SB-GA8-2022-206

Issue 2

Service Bulletin

Airframe Installation of Lycoming Electronic Ignition System (EIS)

Figure 1 – EIS Warning Placard

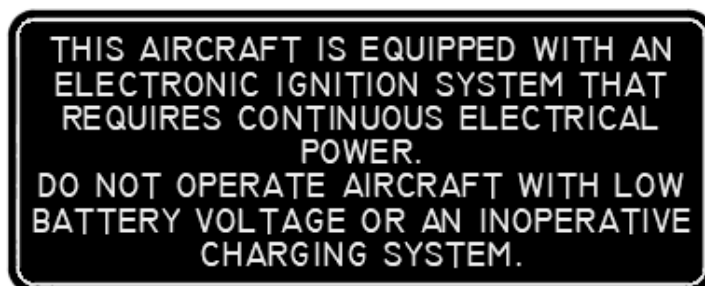
18. Apply Breaker Panel Placard (item 6) to the Circuit Breaker Panel (item 3), refer Figure 2.
19. Apply EIS Warning Placard (item 5) to the instrument panel, adjacent to the ignition switch refer Figure 1.

Figure 6 – Sealing Battery

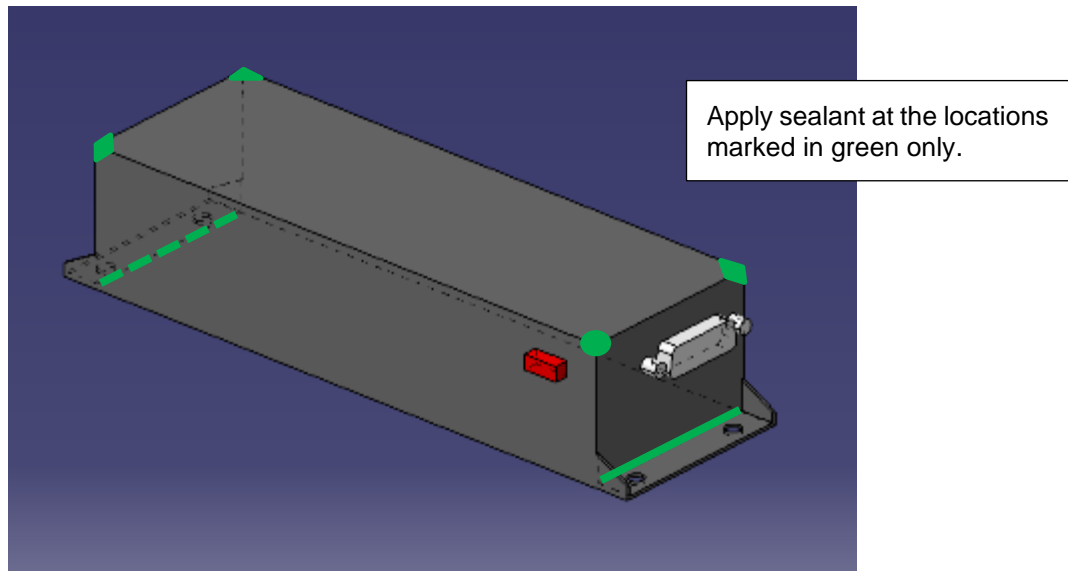
7. Refer Figure 7 through Figure 14. Items used in this section are listed in Table 7 unless stated otherwise.
8. Apply sealant, Item 1 of Table 8, to the battery as shown in Figure 6.

Figure 7 – Bracket Assembly and Nut Plate Installation

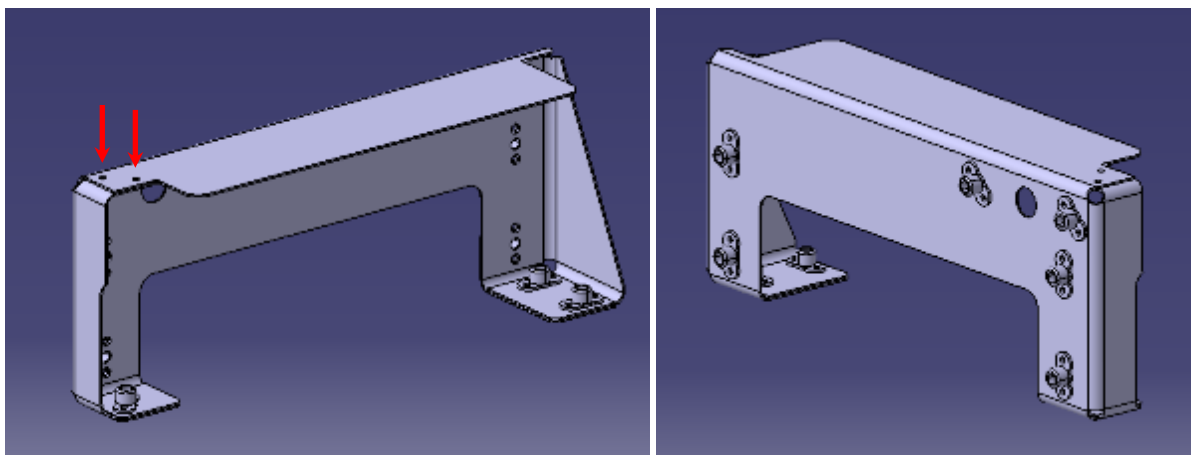
9. Rivet the nut plates (Item 63) to the battery bracket (Item 60) using rivets (Item 64) as shown in Figure 7.
10. Install the two corner rivets (Item 65) at the locations indicated in Figure 7, Left.

Figure 8 – Battery Vent Installation

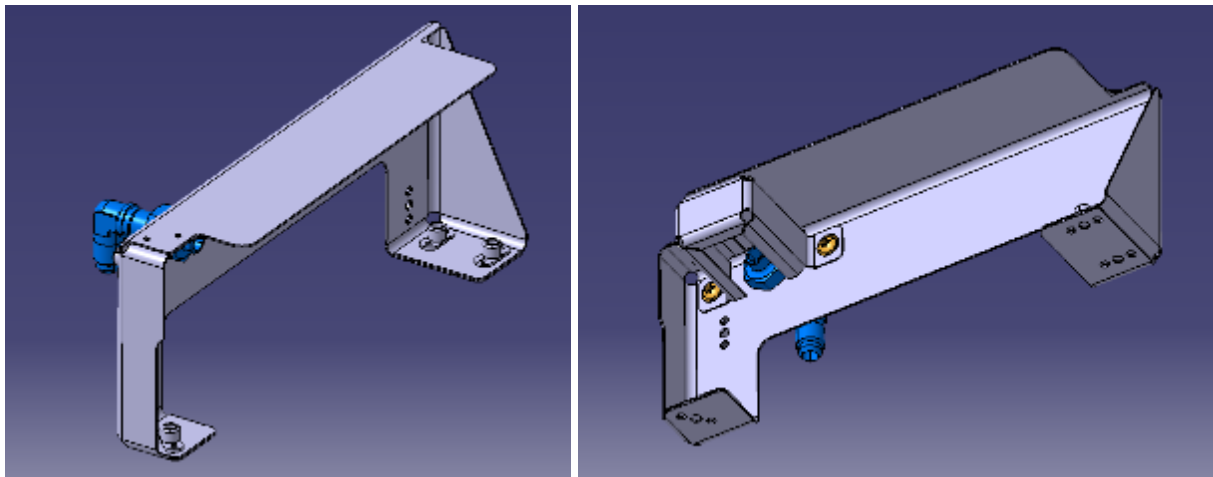
11. Install the elbow fitting (Item 68) using two nuts (Item 69) as shown in Figure 8.
12. Install the battery vent housing (Item 61) using two screws (Item 67) as shown in Figure 8.

Figure 10 – Battery Bracket Installation

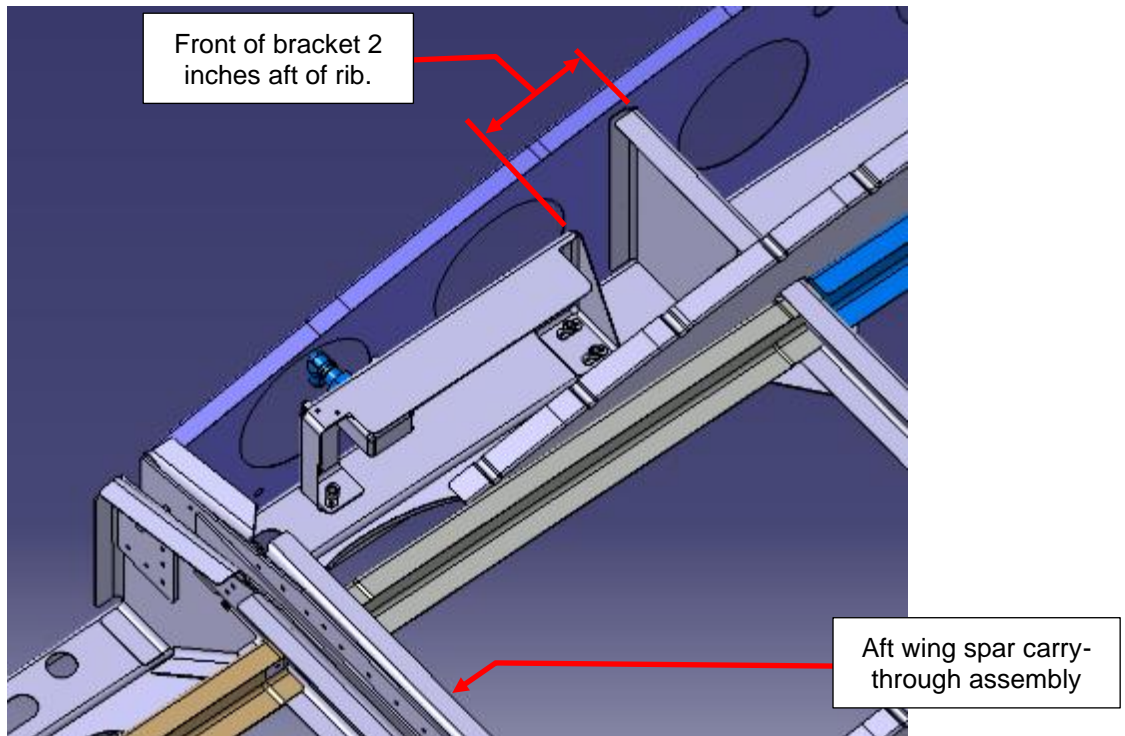
13. Test fit the bracket in port wing root as shown in Figure 10. Ensure clearance between the outboard fuselage wing root rib and the bracket nut plates and screw tails (Figure 12). Mark and drill screw holes.

Figure 11 – Sealing of Battery Vent

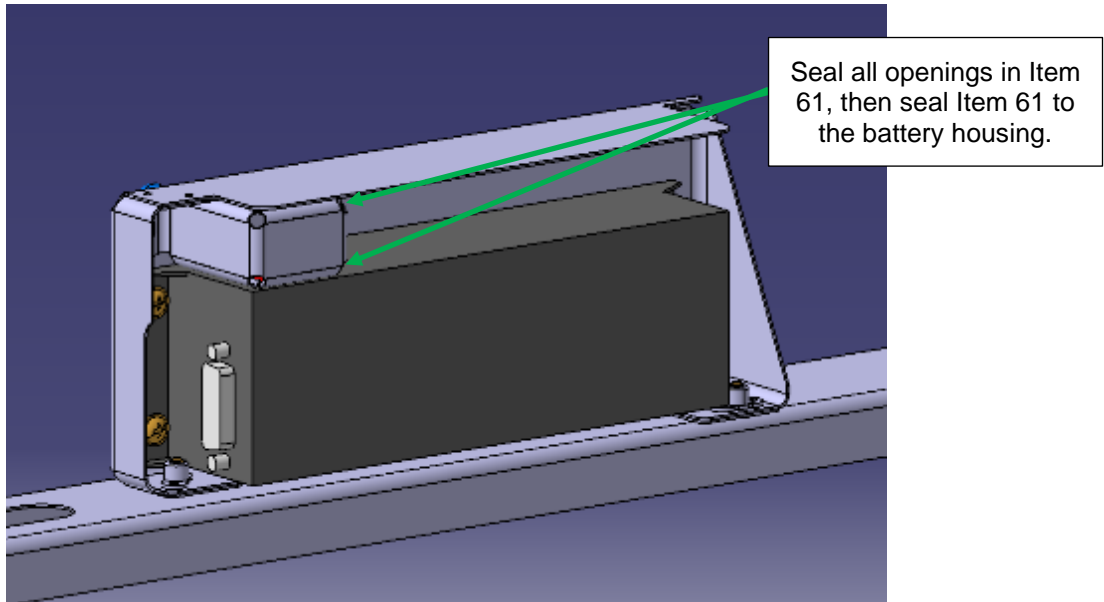
14. Seal the battery vent housing (Item 61) using Item 1 of Table 8 as shown in Figure 11.
15. Fix the battery, bracket and vent assembly in place, using three screws (Item 67).

Figure 12 – Vent Installation

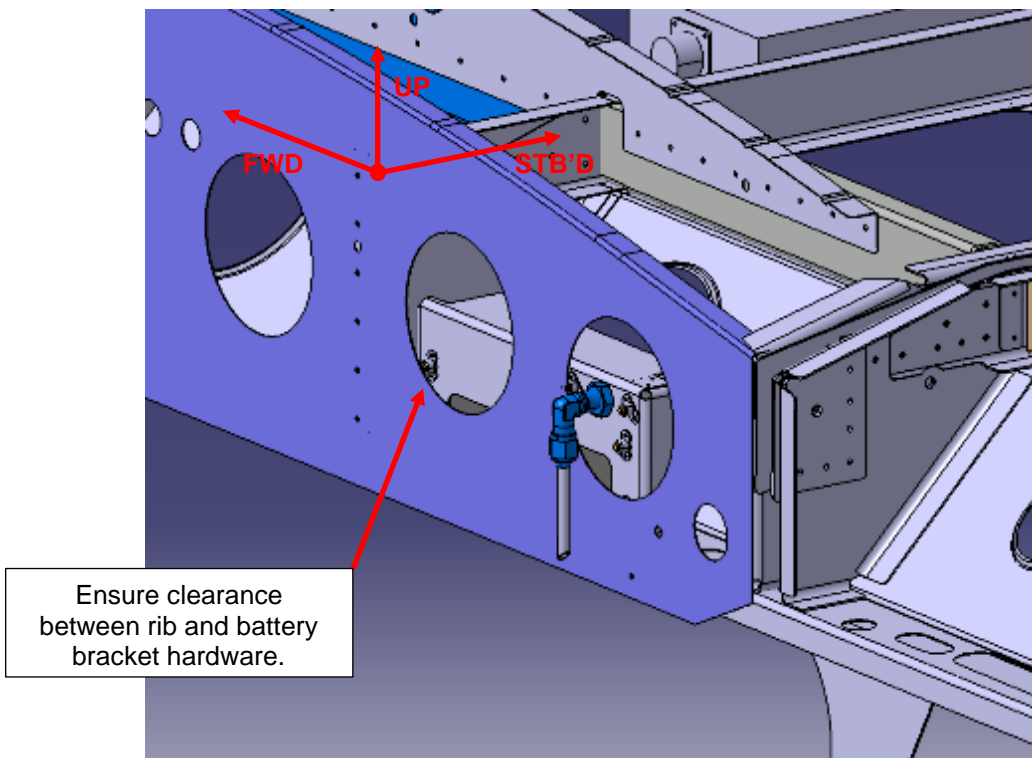
16. Mark the location of the vent outlet on the lower port wing fairing and drill a Ø0.438" hole. Install grommet (Item 71).
17. Fit the battery vent (Item 62) using the sleeve and nut (Item 70 and 69). Direct the vent opening aft as shown in Figure 12. Carefully open and close the rear cabin door while monitoring the gap between the vent and the door. If required, the vent may be shortened to suit, however, the highest part of the vent opening must be at least 0.040" below the lower surface of the grommet.

Figure 14 EL Inverter Assy.

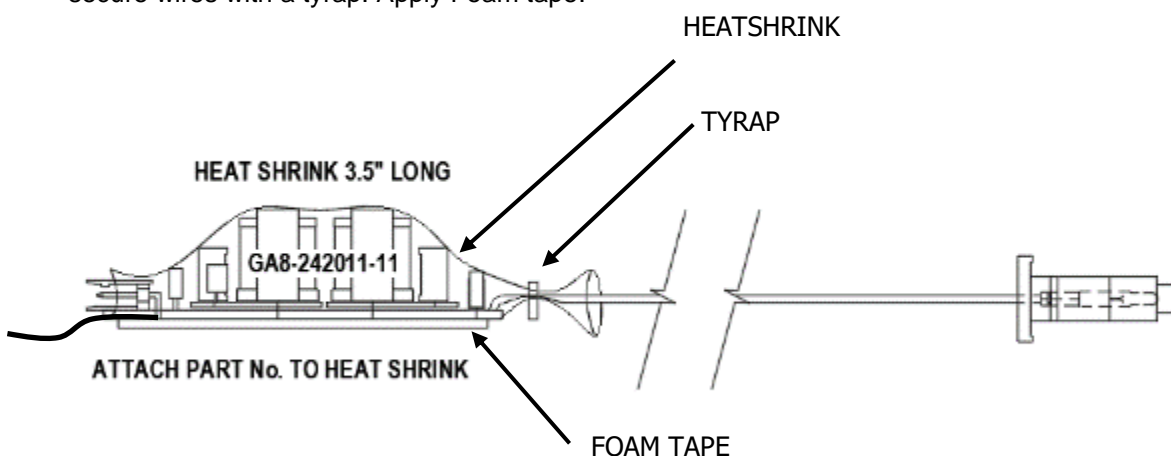
28. Refer Figure 13, slide a new piece of heat shrink over the EL Inverter Assy, shrink using a heat gun, secure wires with a tyrap. Apply Foam tape.

Figure 15 Circuit Breaker & Decal Location

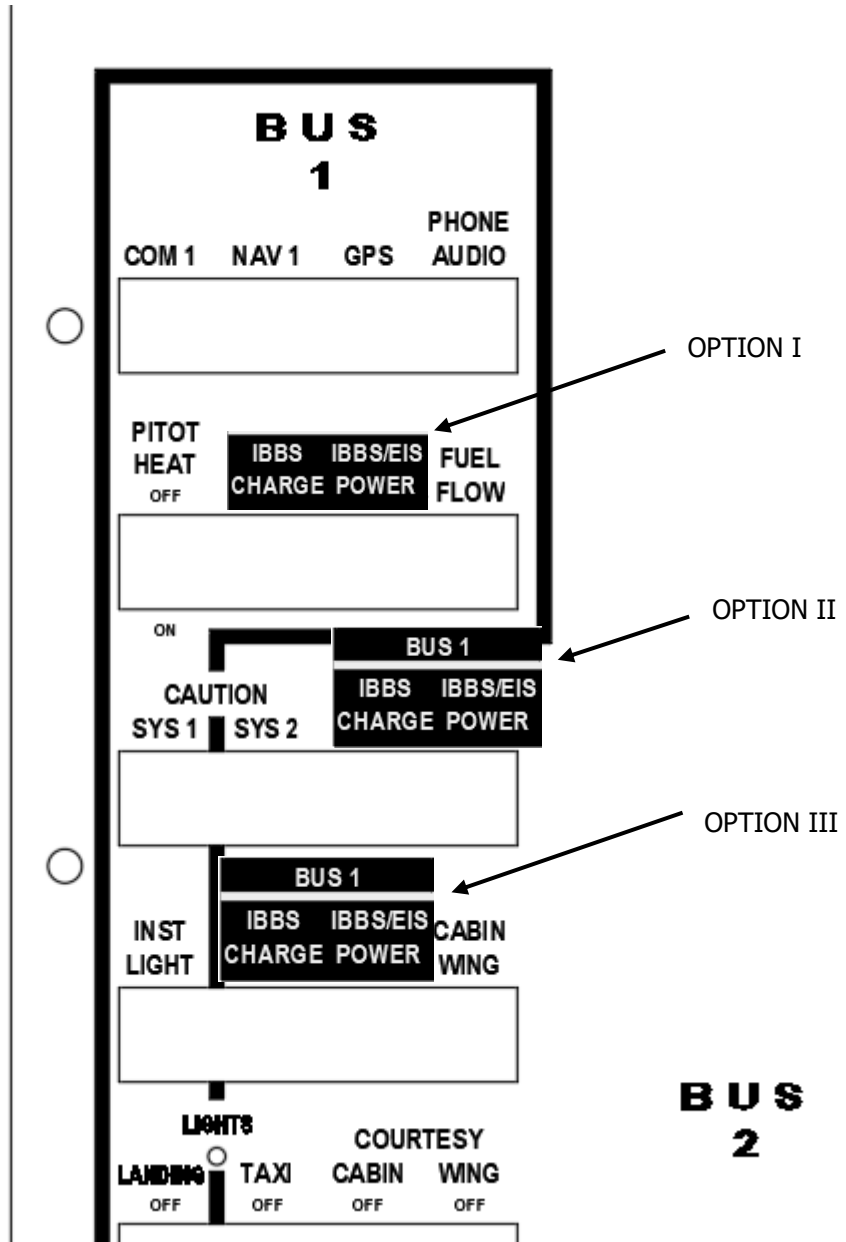
19. Refer Figure 14, the overhead panel requires the installation of the IBBS CHARGE and IBBS/EIS POWER circuit breakers. Both of these circuit breakers are connected to BUS 1 via bus bars and should be installed on LH side of the panel. As the layout of the overhead panel varies depending on both the basic configuration and modified state of the overhead panel there are several options to effect this change.

- (I) Install the IBBS CHARGE and IBBS/EIS POWER into vacant positions on BUS 1.
- (II) If there are no vacant BUS 1 positions any vacant position on the LH side of the overhead panel may be used. Use bus bars (ITEMS 44-46) as required or 8g wire links to connect the circuit breakers to BUS 1.
- (III) If there are no vacant BUS 2 positions on the left hand side of the overhead panel the MAP LIGHT and RADIO LIGHT may be relocated to the RH side of the overhead panel

20. Identify the IBBS CHARGE and IBBS/EIS POWER circuit breakers using the placard (Item 38). For option I, trim the "BUS 1" identifier off the placard if desired.

Figure 16 Switch and LED Cut-Out

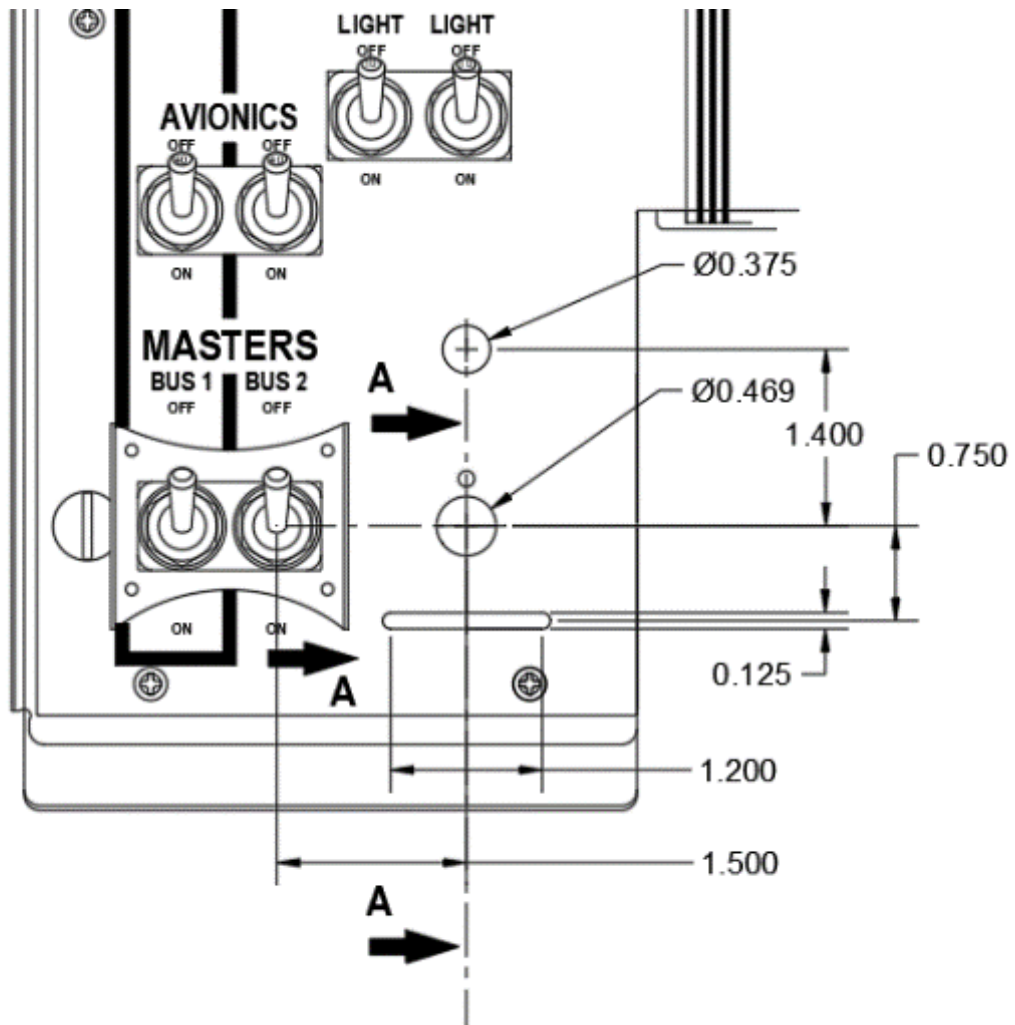
21. Refer Figure 15, cut holes to suit the "LOW VOLT" LED and RH EIS switch. Cut a slot for the electroluminescent strip and radius the slot to remove sharp corners that could damage the strip

Figure 17 View A-A Electro luminescent Strip and Placard Installation

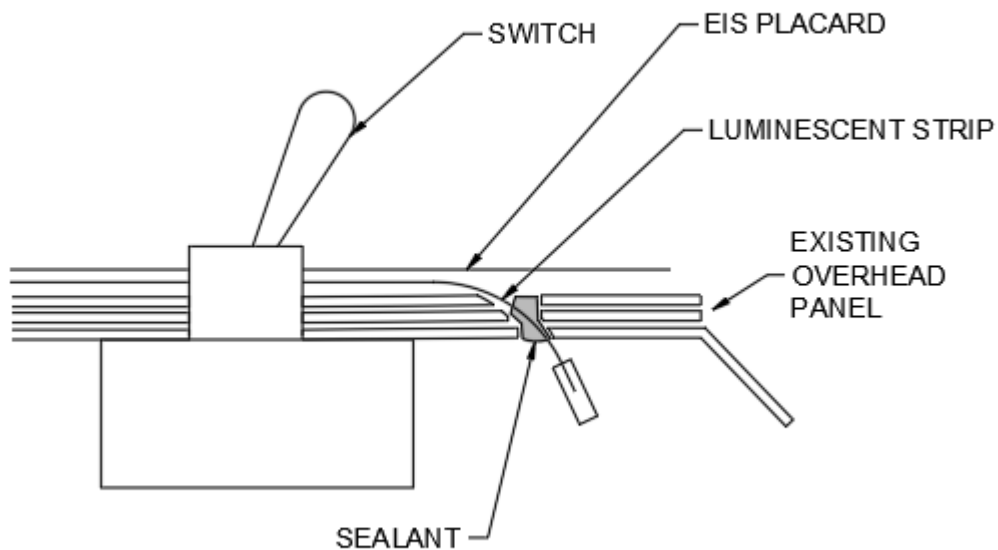
22. Refer Figure 17, trim the electro luminescent strip so that when secured there will be 2.75" showing through the slot. Refer Figure 16, remove the electro luminescent strip backing and secure the strip to the overhead panel

Figure 19 – RH EIS Wiring Diagram

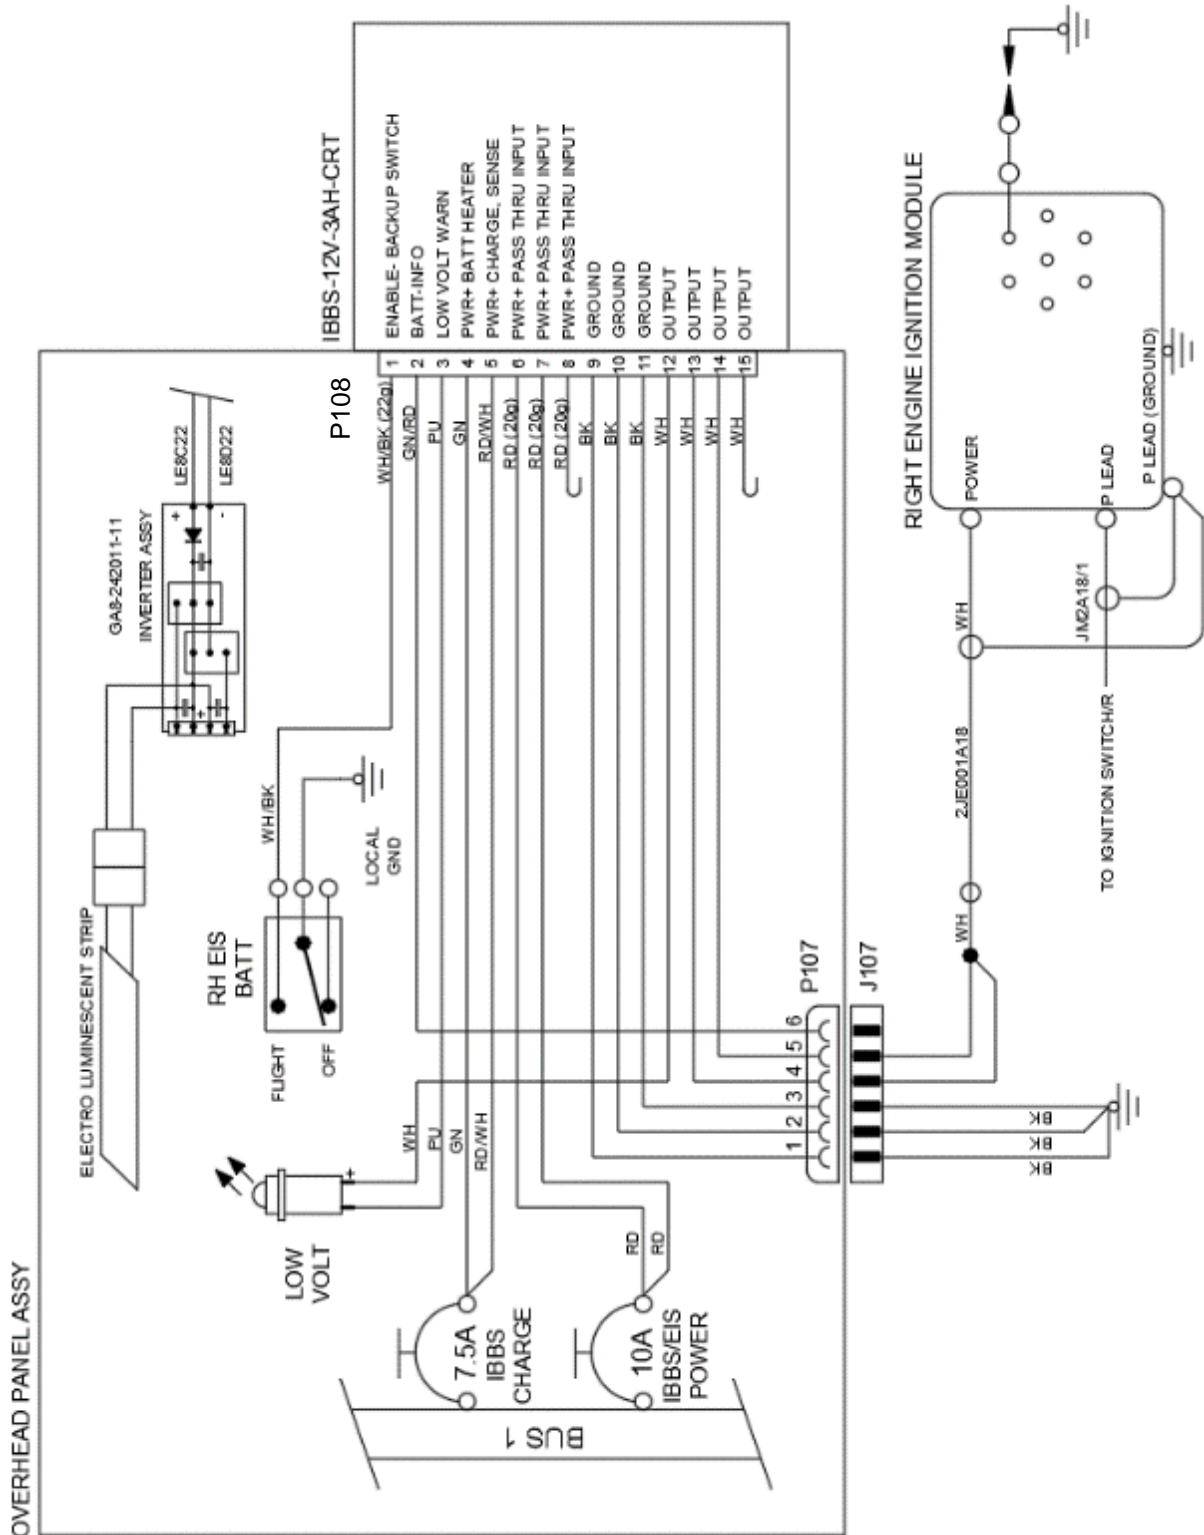
33. Install EIS Power wire 2JE001A18 between RH Engine ignition Module and the J107. Terminate the wire with ring terminals, pin and solder sleeves.
34. Tie the wire into the main loom using lacing tape or tie-wraps
35. Connect wire 2JE001A18 to the Power Terminal of the RH Engine Ignition Module. Connect the power wire shield and P-Lead wire shield to the P-Lead Shield (Ground) terminal.
36. Connect the RH P-Lead to the P-Lead Terminal of the RH Engine Ignition Module
37. Connect wire 2JE001A18/1 to J107 Pins 4 & 5 (item 7). Connect the shield wire to the ground point on the battery tray.
38. Install the ground wires on J107
39. Carry out a continuity check in accordance with Figure 18.
40. Carry out a functional test on all disturbed systems
